Detailed Site Plan
Departure from Parking and Loading Spaces
Alternative Compliance
PMG 8600 Ardwick-Ardmore Road

DSP-18054
DPLS-464
AC-19020

REQUEST	STAFF RECOMMENDATION
DSP: Construction of a gas station and a 2,400-square-foot food and beverage store.	APPROVAL with conditions
DPLS: To allow a reduction of one loading space.	DISAPPROVAL
AC: To allow a reduction of the landscape strip width.	APPROVAL

SUBJECT: Detailed Site Plan DSP-18054
Departure from Parking & Loading Spaces DPLS-464
Alternative Compliance AC-19020
PMG 8600 Ardwick-Ardmore Road

SITE PLAN

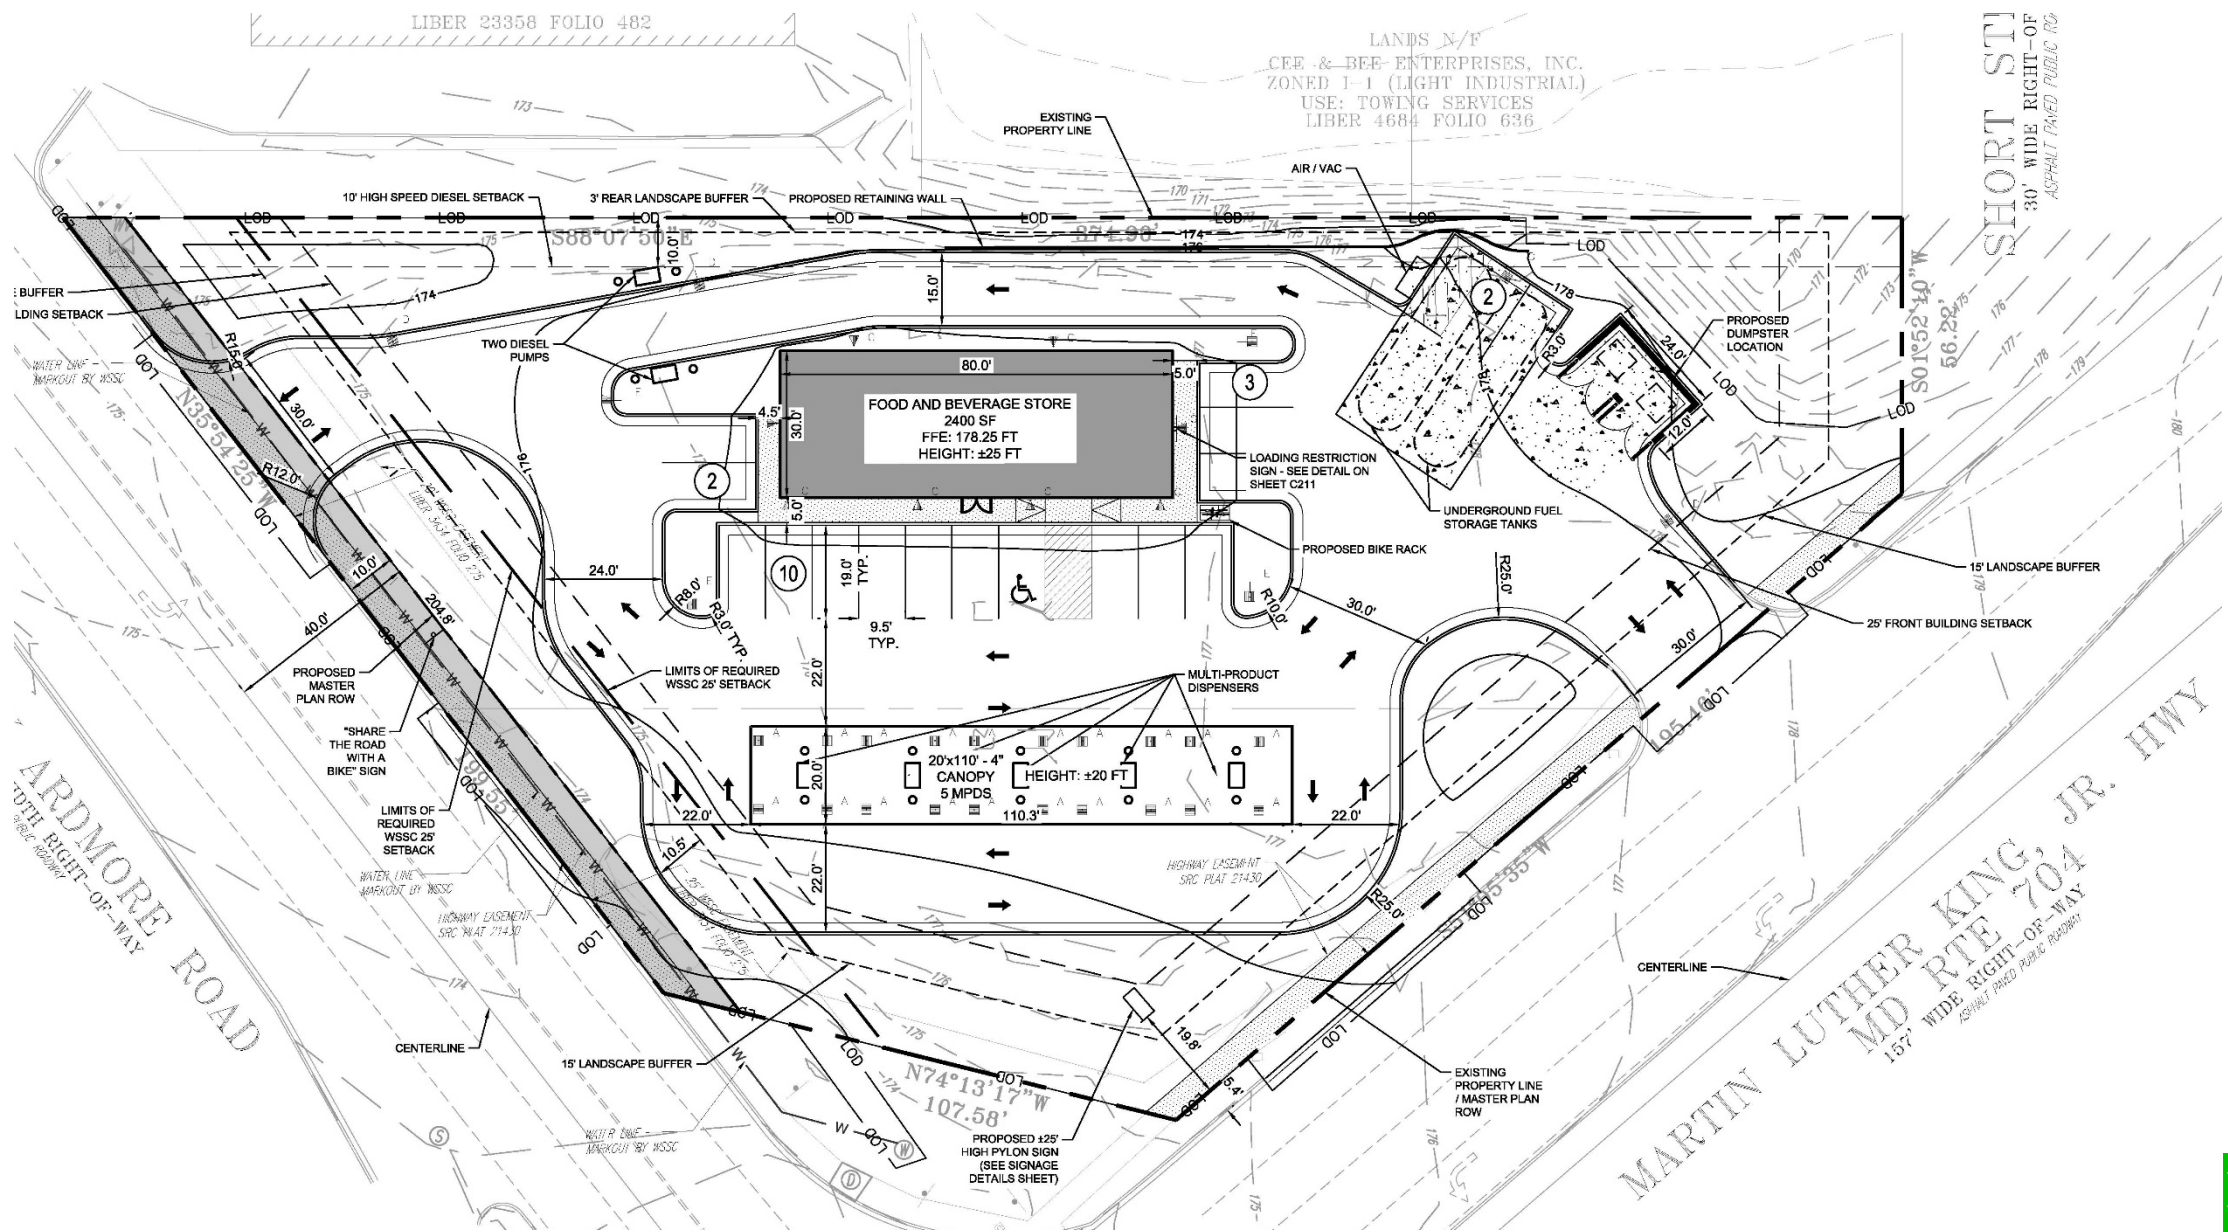
***Staff notes that the parking and loading schedule is unclear and lists the incorrect number of required parking spaces. The schedule should be revised to clearly list the parking requirements of each use. A condition requiring that the parking schedule be revised has been included herein.

All methods for calculating the number of spaces required were not used, as the reduction in standard parking spaces was not calculated correctly. With the allowance of a further reduction in standard parking spaces, there would be additional room on-site to provide the needed loading space.

Based on the analysis above, staff recommends that the Planning Board disapprove DPLS-464 for a reduction of one required loading space, and require the applicant to redesign the site to accommodate the required loading space.

From the standpoint of transportation, it is determined that circulation on the site plan is acceptable and meets the finding required for a DSP, as described in the Zoning Ordinance. However, staff finds that because the site proposes three parking spaces more than required, the site could be reconfigured to provide a loading space by removing some or all of the excess parking spaces. In making this determination, the requested departure is not necessary, is not supportable, and it is recommended that the applicant reconfigure the site to show a loading space, as conditioned herein.

- k. Revise the parking and loading schedule to clearly show the required and proposed spaces for the site for each use demonstrating conformance to Section 27-568 and 27-582 of the Prince George’s County Zoning Ordinance, and correct the zoning section reference for the joint-use of the parking lot.

- l. Redesign the site layout to provide a loading space, in conformance with Section 27-582 of the Prince George’s County Zoning Ordinance.
 - m. Remove the temporary loading space sign restricting loading hours.

- n. Provide additional length and width dimensions for parking spaces throughout the site demonstrating conformance to Section 27-558 of the Prince George’s County Zoning Ordinance.

LANDSCAPE PLAN

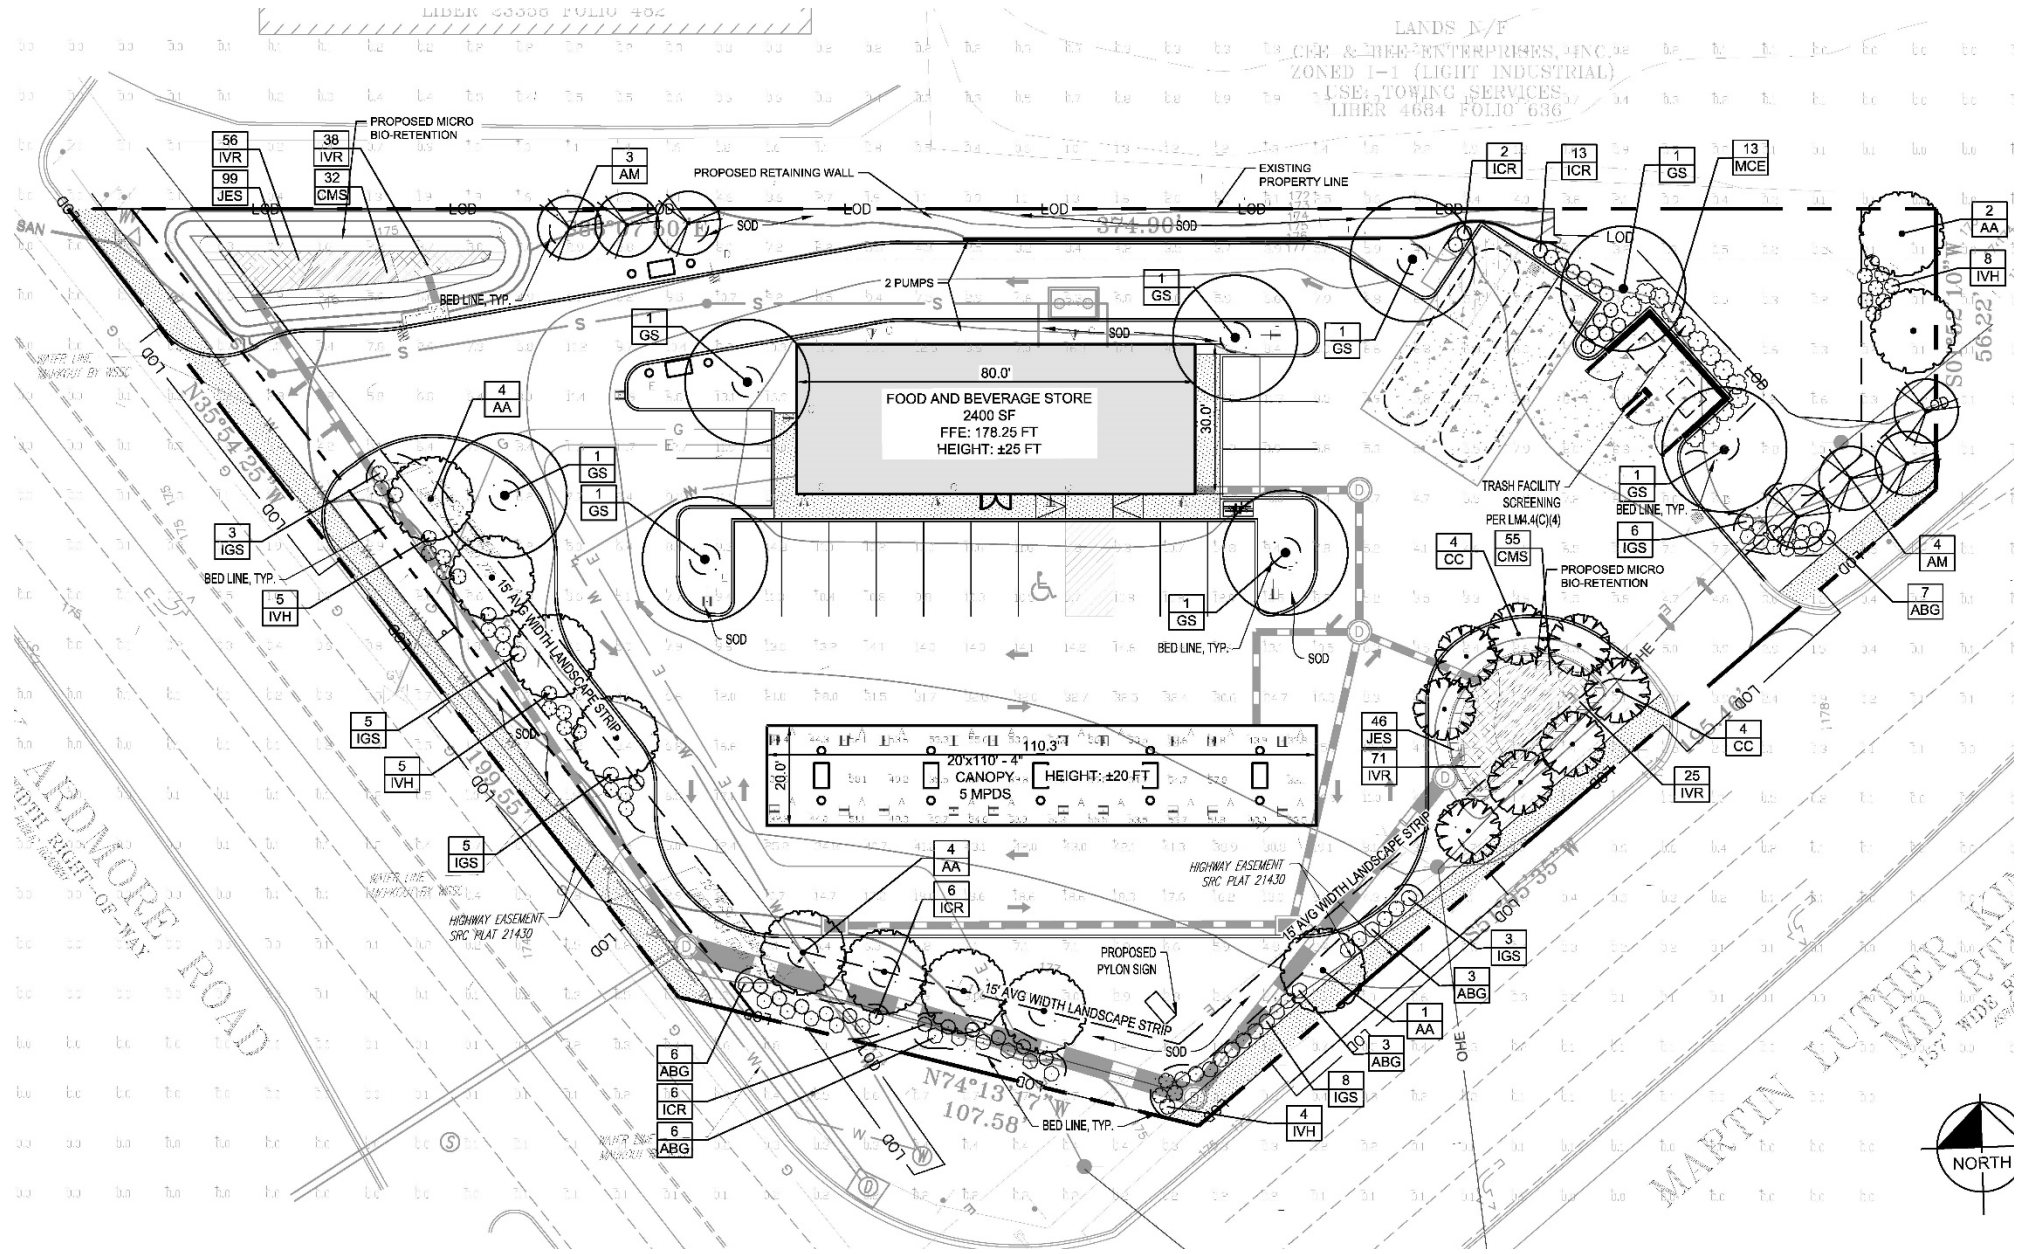
8. **2010 Prince George's County Landscape Manual:** The application is subject to the requirements of the 2010 *Prince George's County Landscape Manual* (Landscape Manual) for Section 4.2, Landscape Strips along Streets; Section 4.3, Parking Lot Requirements; Section 4.4, Screening Requirements; Section 4.7, Buffering Incompatible Uses; and Section 4.9, Sustainable Landscaping Requirements. Staff notes that it is unclear where the location of some of the required buffers and landscape strips are located on the plan.

Ardwick-Ardmore Road: The landscape strip along Ardwick-Ardmore Road is 265 linear feet, and the average width of 15 feet has been provided along most of this length, with one exception. Directly west of the proposed fuel canopy, the proposed drive aisle limits the width of the landscape strip to as little as 4 feet along approximately 20 linear feet of the frontage. A total of 118 planting units, consisting of 8 shade trees and 38 shrubs, is required in the landscape strip. As proposed, a total of 127 plant units, consisting of 8 shade trees and 47 shrubs, has been provided. The total number of plant units provided exceeds the minimum requirement by approximately 7 percent. In order to demonstrate the alternative proposed landscape strip can be equally effective as normal compliance, the quantity of proposed plantings should be increased to at least 10 percent more than the minimum number of plant units required. To meet these criteria in the landscape strip on Ardwick-Ardmore Road, a minimum of four additional plant units should be provided, which equates to an additional four shrubs, or a single ornamental or shade tree.

MD 704: The landscape strip along MD 704 is 165 linear feet, with an average width of 15 feet provided along most of this length, with one exception. Directly east of the proposed fuel canopy, the proposed drive aisle limits the width of the landscape strip to as little as 4 feet along approximately 35 linear feet of frontage. A total of 74 plant units, consisting of 5 shade trees and 24 shrubs, is required in the landscape strip. As proposed, 1 shade tree, 8 ornamental trees, and 30 shrubs, totaling 80 plant units, has been provided. The total number of plant units provided exceeds the minimum requirement by 8 percent. In order to demonstrate the alternative proposed landscape strip can be equally effective as normal compliance, the quantity of proposed plantings should be increased to at least 10 percent more than the minimum number of plant units required. To meet these criteria in the

The additional plant units should be provided in the southern portion of the site, near the intersection of Ardwick-Ardmore Road and MD 704, in the general area of the proposed pylon sign. The landscape strips associated with the roadways converge and enlarge in this location, and it can accommodate four additional plant units for the landscape strip along Ardwick-Ardmore Road and two additional plant units for the landscape strip along MD 704.

- i. Clearly label the location of the required landscape buffers and strips on the landscape plan.

- o. Provide an additional minimum four plant units in the Section 4.2 landscape strip along Ardwick-Ardmore Road, proximate to the proposed pylon sign. Update the planting schedule accordingly.

- p. Provide an additional minimum two plant units in the Section 4.2 landscape strip along MD 704 (Martin Luther King Jr Highway), proximate to the proposed pylon sign. Update the planting schedule accordingly.

ARCHITECTURE - CANOPY

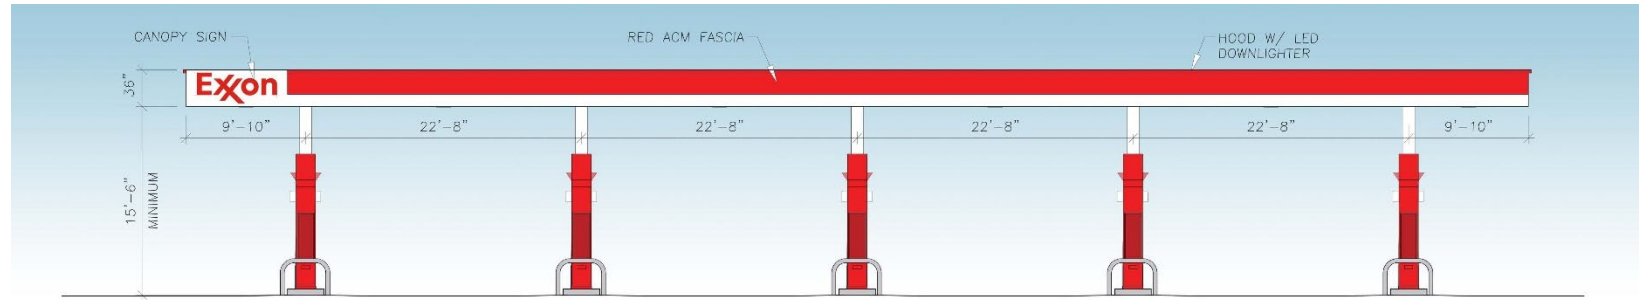
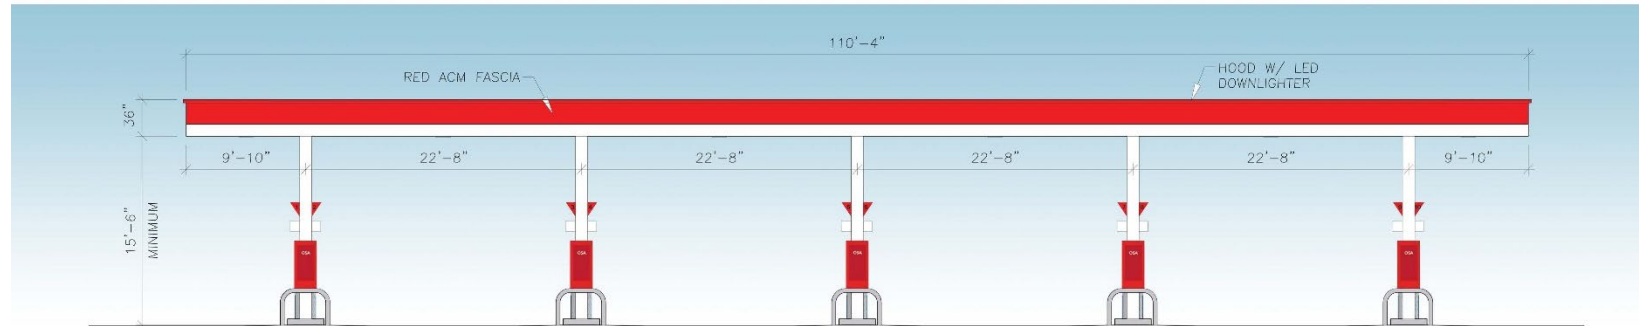
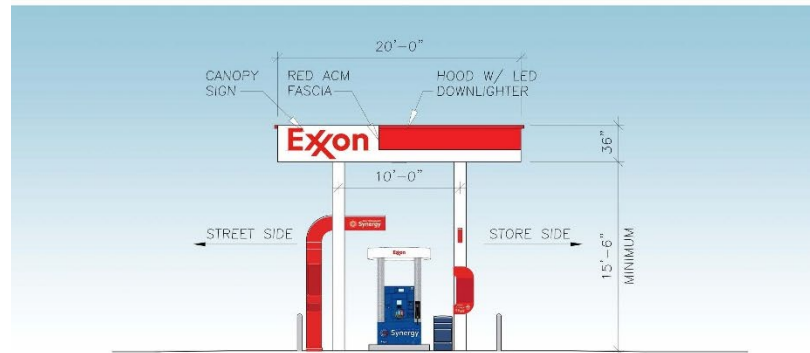
Note: *A signage area schedule was not provided and should be shown with this DSP, demonstrating conformance to Sections 27-613 and 27-614. Additionally, it is noted that the elevations provided do not clearly indicate the building-mounted signs that are proposed on the food and beverage building, and should be revised. Conditions have been included herein requiring the applicant to provide the signage area schedule and clarification for which signs are being used on the food and beverage building.

- e. Clearly label on the elevation the type of building-mounted signs that are being used on the food and beverage building.
 - f. Provide additional architectural treatments on the side and rear elevations of the building, including the use of faux windows, brick insets, service doors, and/or vertical banding.

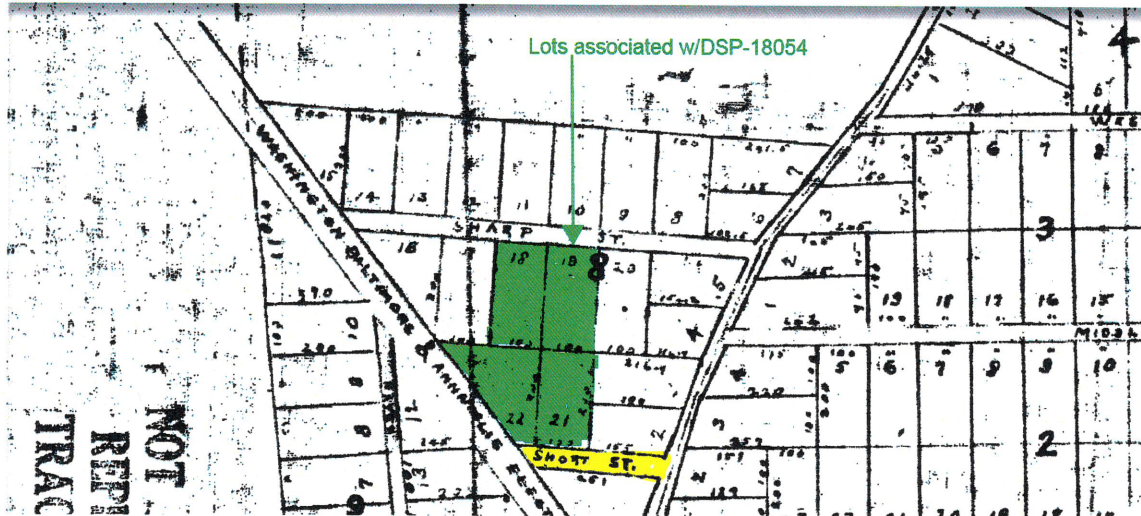
3. Provide length and width dimensions of at least one of the parking spaces in each of the two 3-space parking banks at either end of the convenience store and the 2-space bank on top of the underground fuel storage tanks.
4. Applicant did not provide architectural elevations.
5. Clearly define the limits of the retaining wall length at the rear of the property around the diesel fuel dispenser. It is unclear where the wall terminates to the east.
6. Show retaining wall height and type on site plan.
7. Show height of monument sign on site plan.
